ADDENDUM NO. 02

March 16, 2020

PRIDE ACADEMY AT PROSPECT AVE SCHOOL – LEARNING RESOURCE CENTER (LRC) – 04-118742

SANTEE SCHOOL DISTRICT

SHEET NO. AD2-E2.1

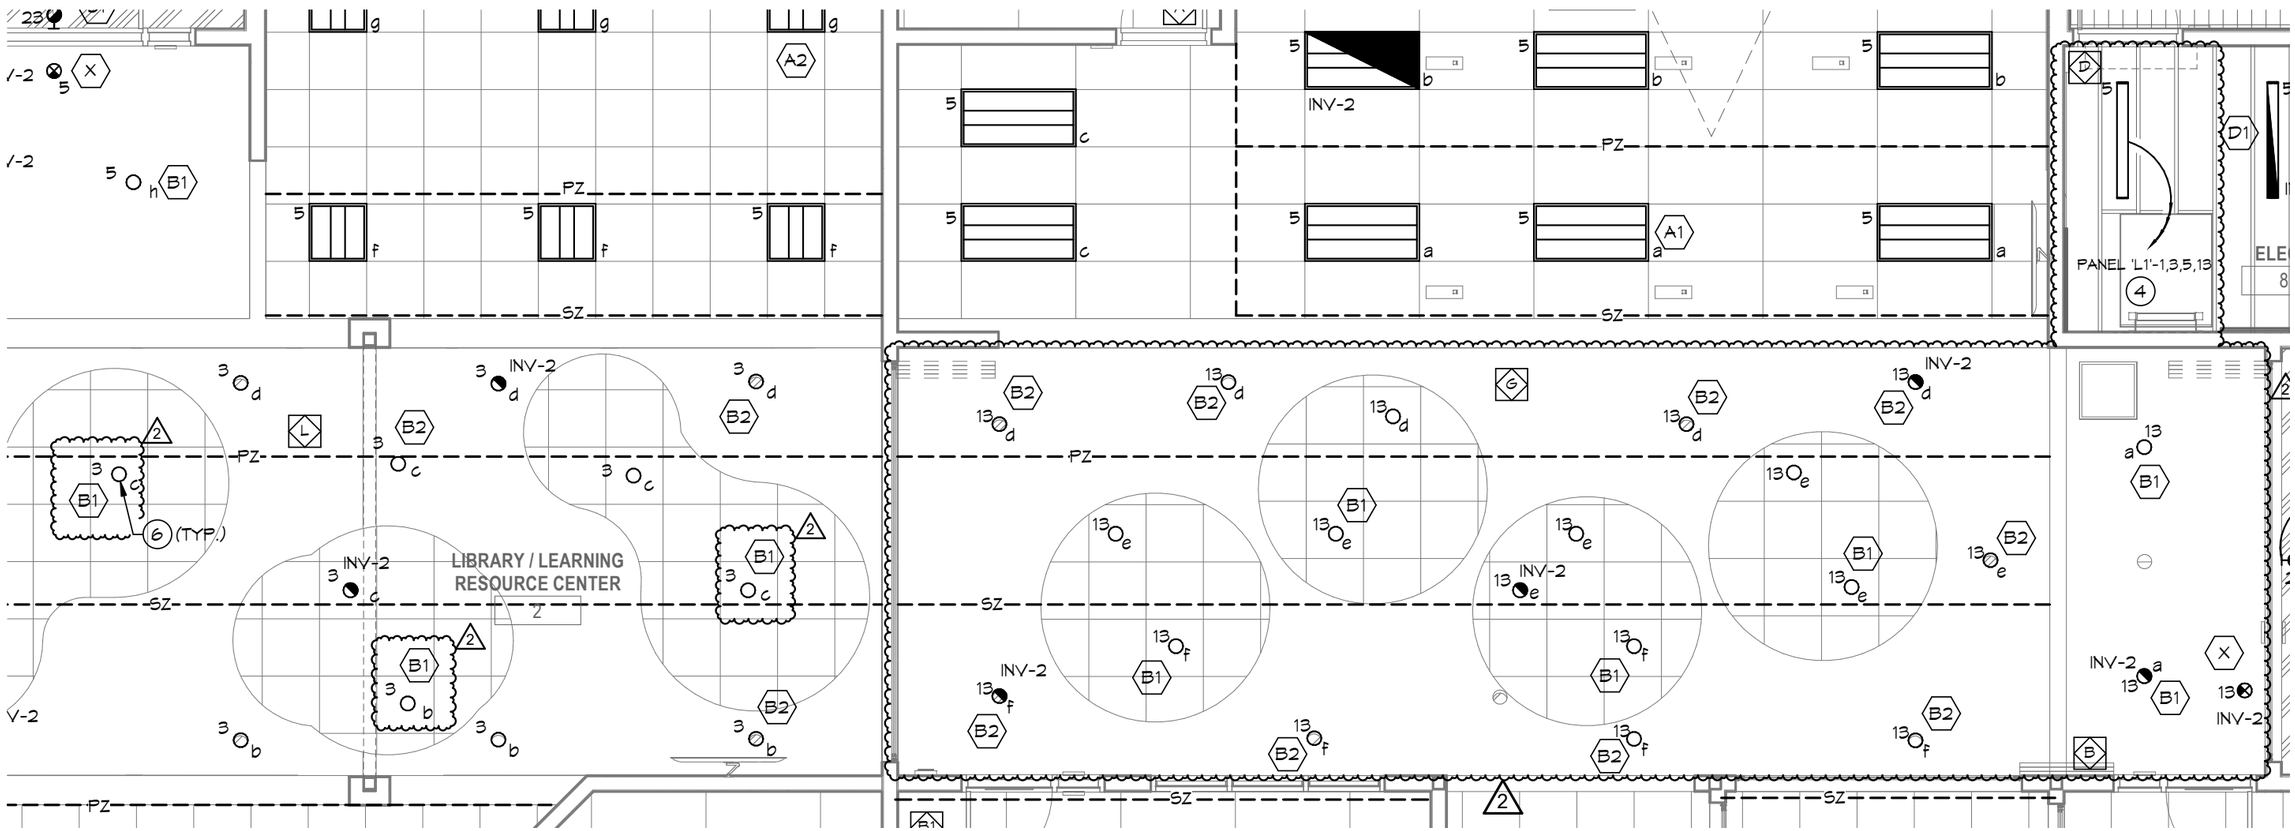
A. Revise sheet E2.1 Level 1 Floor Plan- Lighting to show updated fixture references, per AD2-E2.1.

SHEET NO.
AD2-E4.6

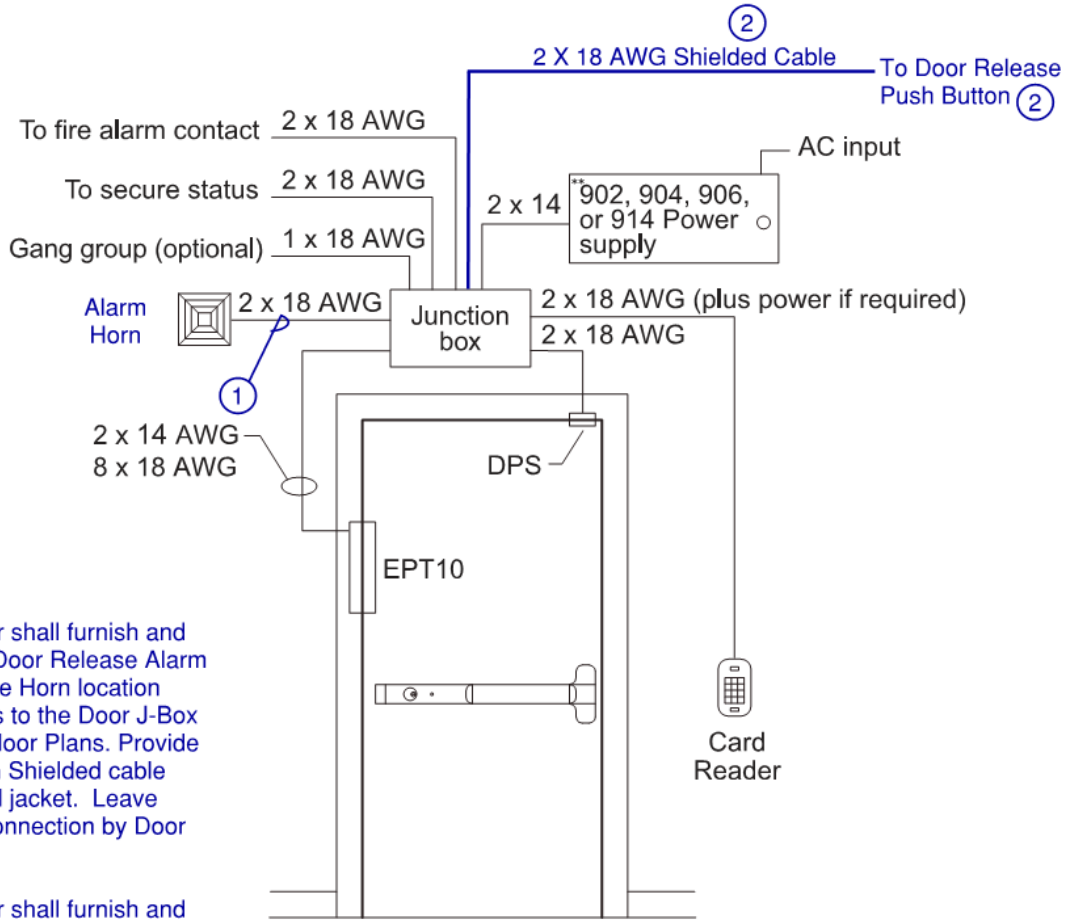
A. Revise sheet E4.6 Classroom Audio-Visual Details, to add detail 5, per the attached AD2-E4.6.

(1) The 27 10 00 Contractor shall furnish and install the cable for the Door Release Alarm Horn. Run cable from the Horn location shown on the floor plans to the Door J-Box location shown on the Floor Plans. Provide a 2-Conductor, 18-AWG Shielded cable with a CM or CMR-rated jacket. Leave slack at both ends for connection by Door Contractor

(2) The 27 10 00 Contractor shall furnish and install the Door Release Push Button and cable to Door J-Box. Run cable from the Push Button location shown on the floor plans to the Door J-Box location shown on the Floor Plans. Provide a 2-Conductor, 18-AWG Shielded cable with a CM or CMR-rated jacket. See specifications for Push Button requirements

SHEET NO. AD2-E5.3

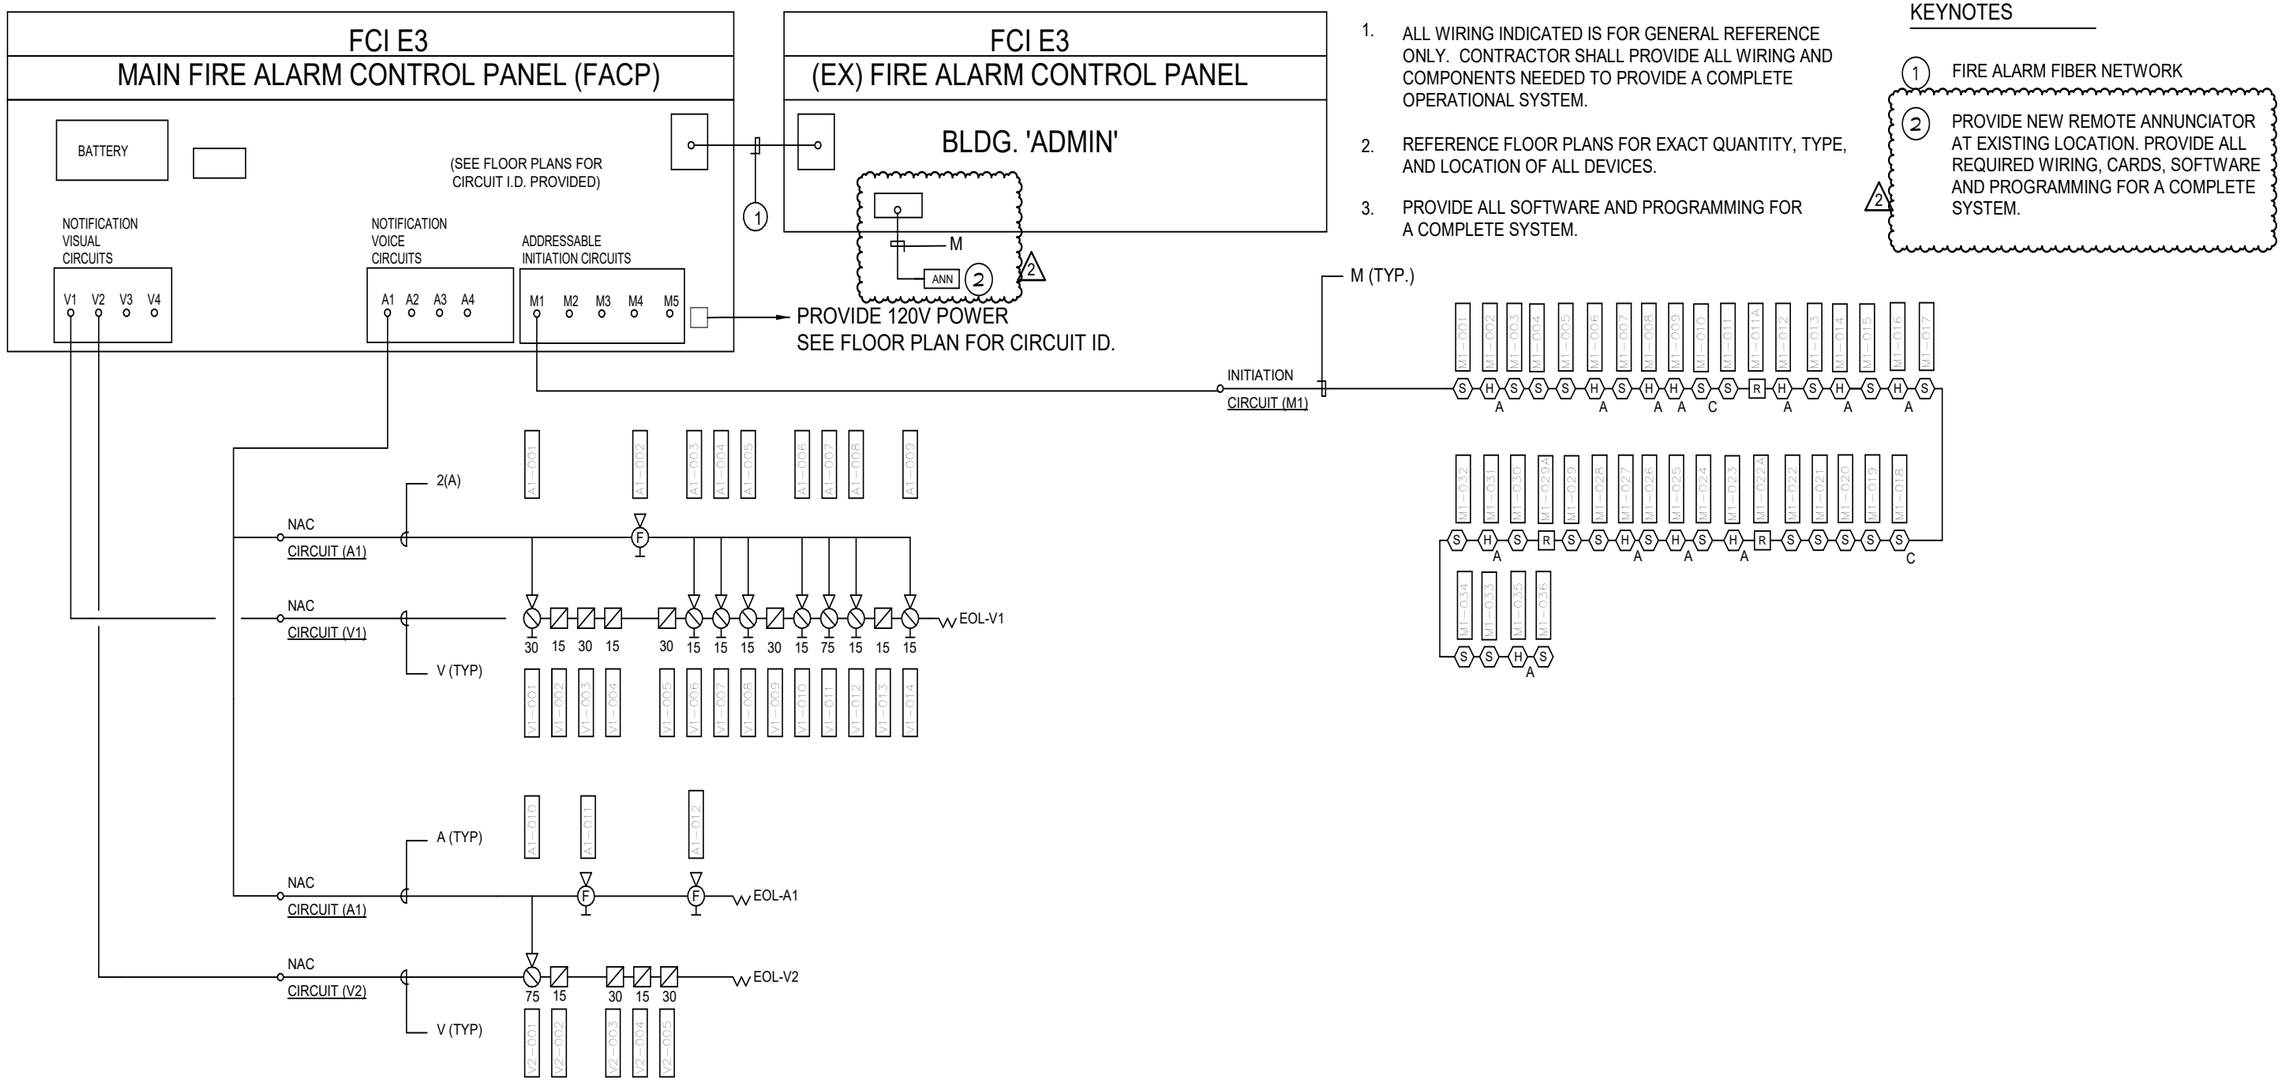
A. Revise sheet E5.3 to show revised riser diagram, per AD2-E5.3

1. FIRE ALARM FIBER NETWORK
2. PROVIDE NEW REMOTE ANNUNCIATOR AT EXISTING LOCATION. PROVIDE ALL REQUIRED WIRING, CARDS, SOFTWARE AND PROGRAMMING FOR A COMPLETE SYSTEM.
